File No.: 19-9930

May 7, 2020

**Request for Class 4 (NPC-300) Designation
Proposed Creekside Condominium Development
Ellis Street and Trinity Avenue, LaSalle ON**

title:
SITE PLAN

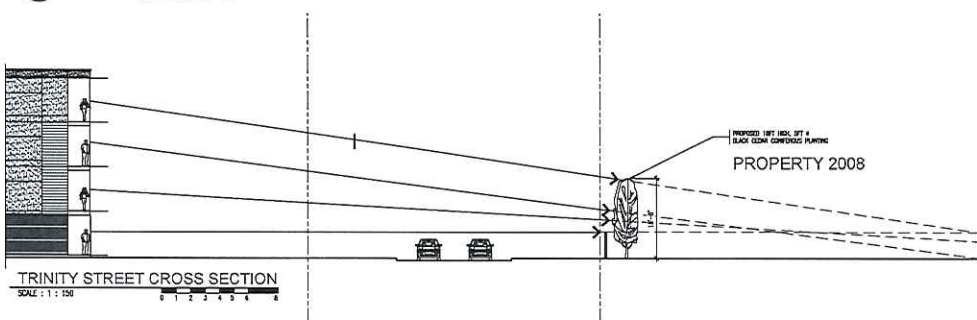
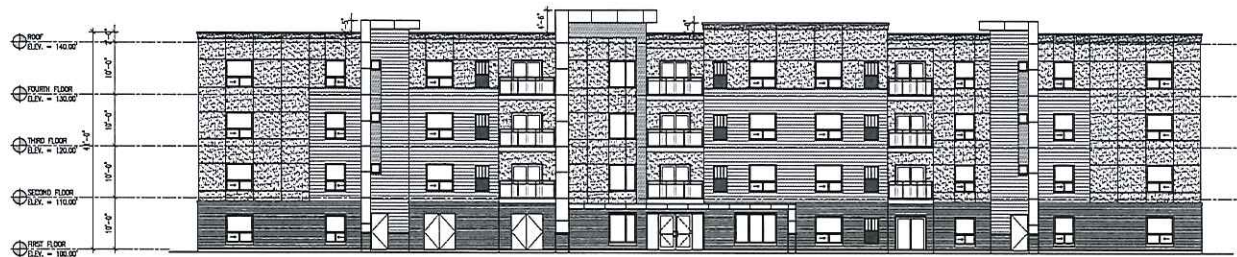
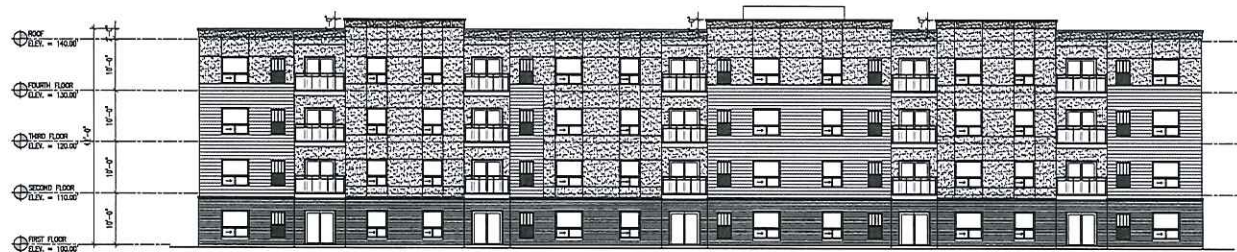
4. **Revised Site Plan Control Drawings:** To assist Council and the Town in their deliberations, we have included a revised set of Site Plan and Building Elevation drawings for consideration (refer to Appendix "A" – Site Plan and Elevations). The most significant changes from the previous version is:
 - a. The removal of balconies on the west side of Building B and the north side of Building C both elevations are facing the Loblaws loading dock and roof top cooling units;
 - b. The addition of Garages C1 and C2 adjacent to the northern property line shared with Loblaws; and

- c. The addition of a 1.8m pressure treated wood fence to be constructed as a noise barrier (20kg/m2 density) on our clients' lands adjacent to the shared Loblaws property line.
